**ADDENDUM NO. 2**

PROJECT: COVINA-VALLEY UNIFIED SCHOOL DISTRICT  
Fencing at Northview High School 14-15-107

April 22, 2015

SUBJECT: SPECIFICATIONS AND DRAWINGS

TYPICAL FENCE ELEVATION / SECTION

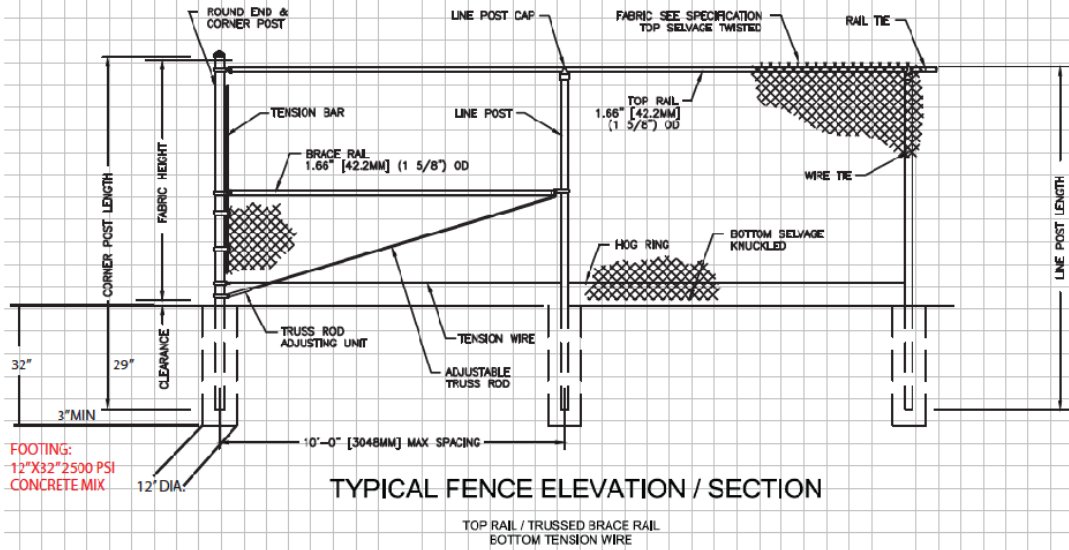
I received one question as follows: Can you please indicate the footing size. Diameter and depth?

See drawing below with footing size, diameter and depth indicated in **Red**:
